06-324r6 SAS-2 Modifications to the SAS Speed Negotiation

To: T10 Technical Committee  
From: Amr Wassal, PMC-Sierra (amr\_wassal@pmc-sierra.com)  
Stephen Finch, STMicroelectronics (steve.finch@st.com)  
Date: 20 September 2006  
Subject: 06-324r3 SAS-2 Modifications to the SAS Speed Negotiation

[Revision 6 \(19 October 2006\) Updates per 19 October 2006 conference call. We reviewed down to the middle of section 6.7.4.2.4.](#)

**Figure 122 — SAS SNW-1, SNW-2 and Final-SNW**

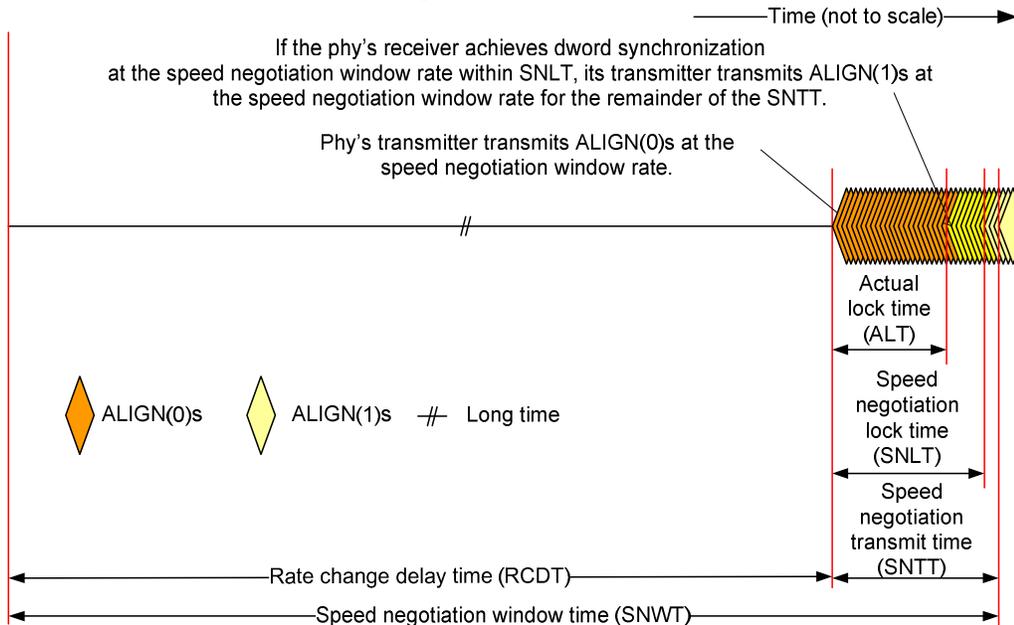
<<Rev 5 added periods to sentences in figure 122>>

Figure 123 — SAS SNW-3

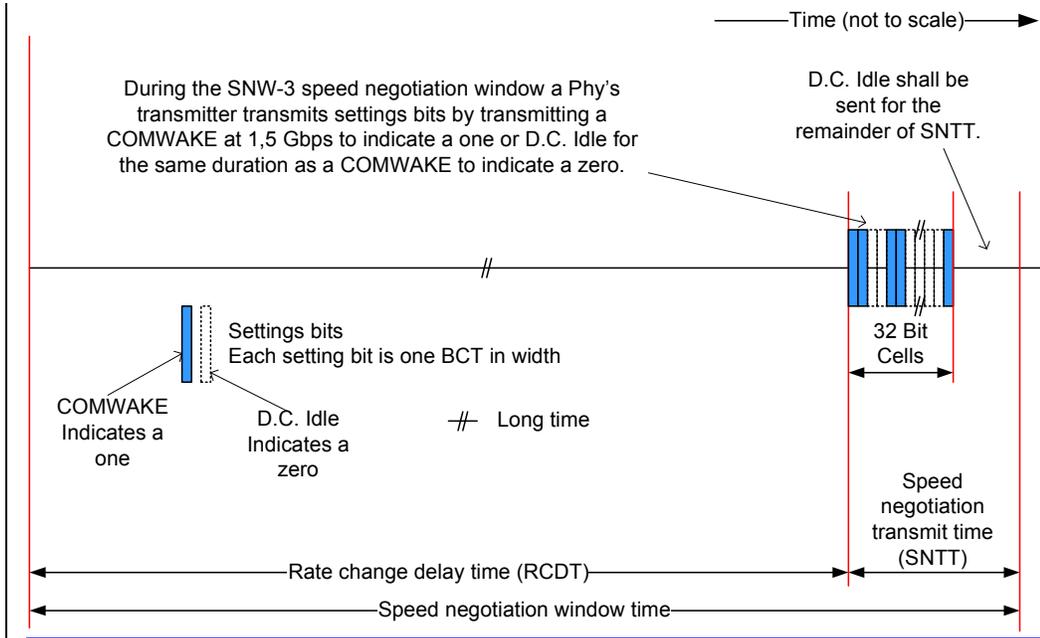
<Rev 6 changed "1" and "0" to one and zero in figure 123.>

Figure 124 — SAS Train-SNW

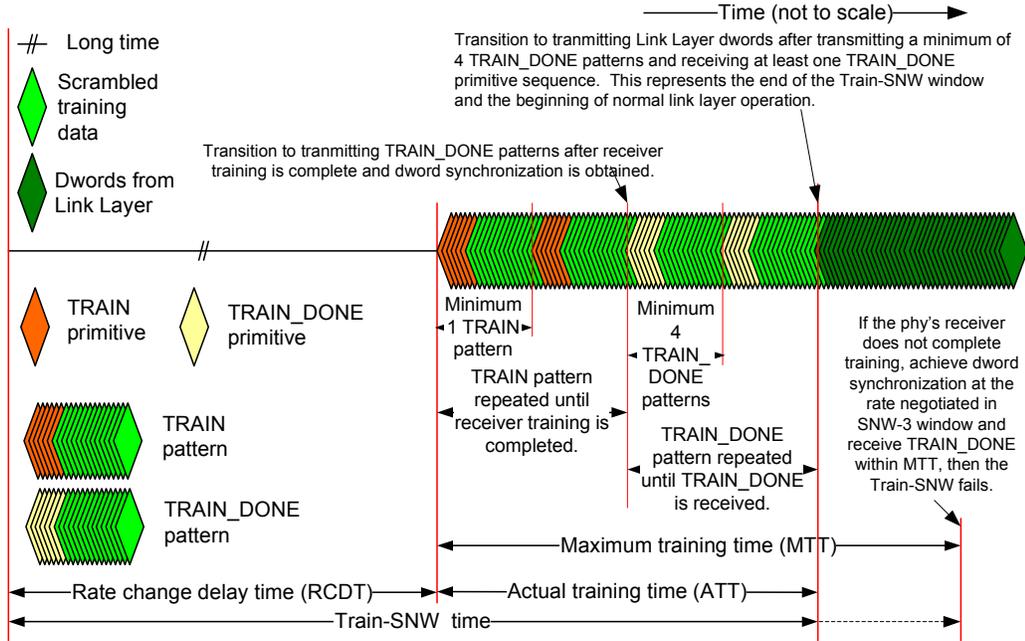
<Rev 5 added periods at the end of sentences, removed periods from descriptors in figure 124.>

Figure 126 — SAS Final-SNW phy reset problem

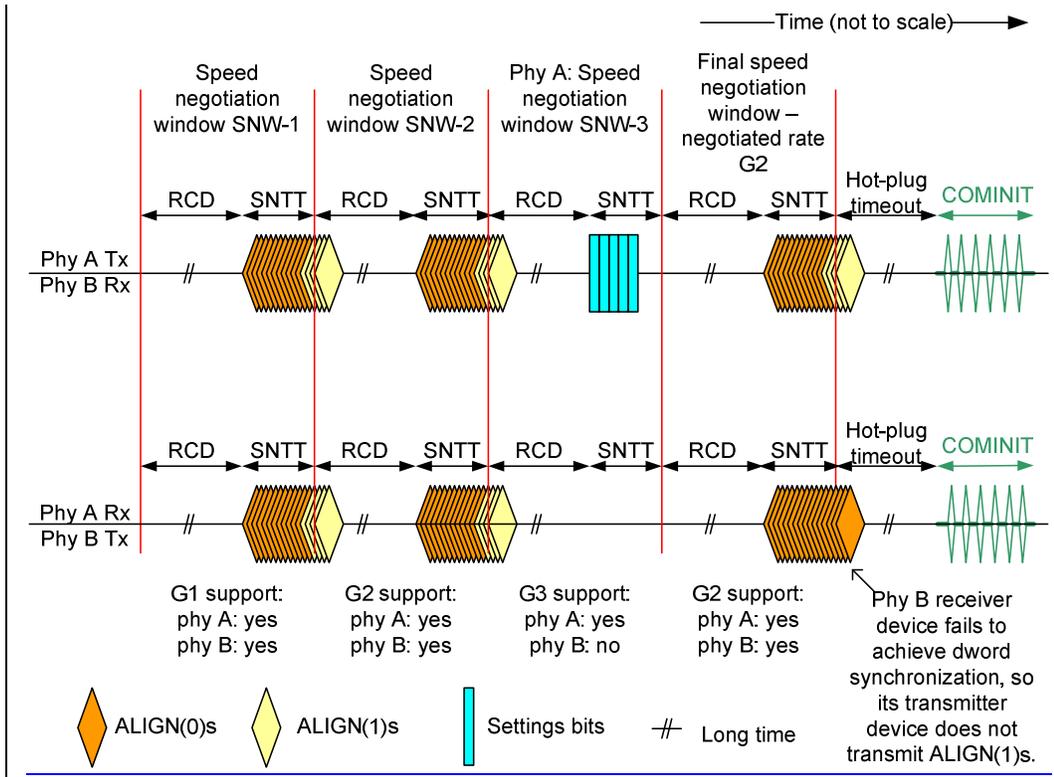
<Rev 5 added periods at the end of sentences, removed periods from descriptors in figure 126.>
